Clause 163, 120F Comment Resolution

Phil Sun

Credo Semiconductor

Figure 93C-4—Interference tolerance channel s-parameter test setup

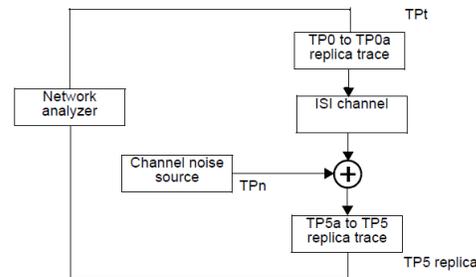
CI 163 SC 163.9.3.3 P 181 L 42 # 71
Ran, Adee Intel
Comment Type T Comment Status D RITT

In item b, Equation 163-2 is a calculation of A_{DD} , not related to return loss.

The transmitter's test fixture only has an ERL spec, and that is defined from TP0v towards the DUT. It is not an appropriate ERL for TP5 replica (e.g. has only N=20 UI).

The breakout from the package is typically controlled by the PMD's vendor and is practically part of the DUT. Therefore we should not add ERL specifications for the TP5 replica - they may be irrelevant and even incorrect for a specific implementation.

This is similar to the case of a transmitter's test fixture where ERL is specified toward the DUT, but not from the DUT toward TP0v.

Instead, the test channel's ERL should be specified to meet the ERL specifications in 163.10.3.

Also applies in 120F.3.2.3 item b which has "The return loss of the test setup in Figure 93C-4 measured at TP5 replica towards TPt meets the return loss specifications in 163.9.2.1" - but there are no return loss specifications in 163.9.2.1 anymore.

- b) The return loss of the test setup in Figure 93C-4 measured at TP5 replica towards TPt meets the requirements of Equation (163-2).

Equation 163-2 is nothing to do with return loss. Also it would be better to use ERLas the parameter.

The reference equation, Equation (163-2), is not correct. It shall be the original equation (equation 163-2) in D1p2 and be removed from D1p3.

The return loss of the test channel measured at TP5a towards TPt meets the requirements in 163.10.3.

Apply similar change in 120F.3.2.3 with the reference to requirements in 120F.4.3 instead.

Replace item b with "The return loss of the test channel measured at TP5a towards TPt meets the requirements in 163.10.3."

Change to "The ERL of the test setup in Figure 93C-4 measured at TP5 replica towards TPt meets the requirements for ERL in 163.9.2.1.2 with the exception that the length of the reflection signal N is 3500 UI"

Resolve using the response to comment #71

Resolve using the response to comment #71
